Addendum for Emergency Power Off and UPS Firmware Troubleshooting

990-5439
8/2014

Install a Ferrite Bead

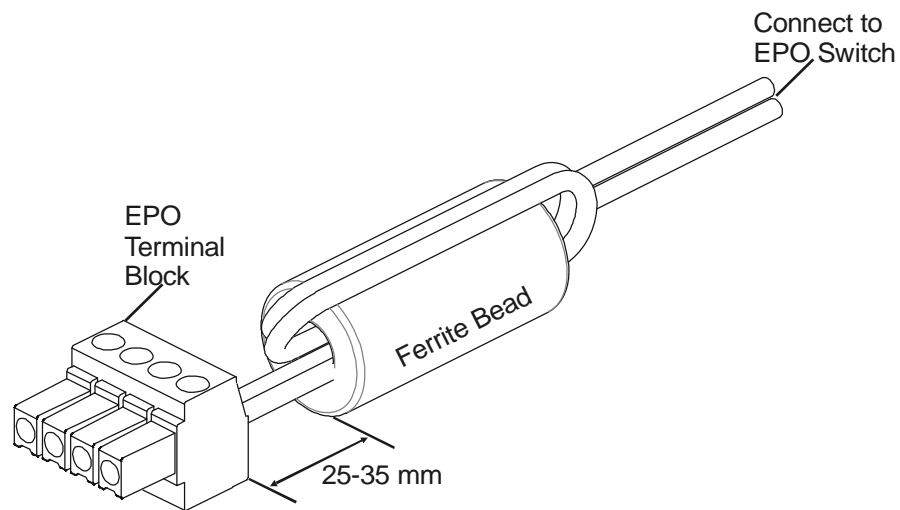
The supplied ferrite bead must be installed between the supplied EPO terminal block and the EPO switch.
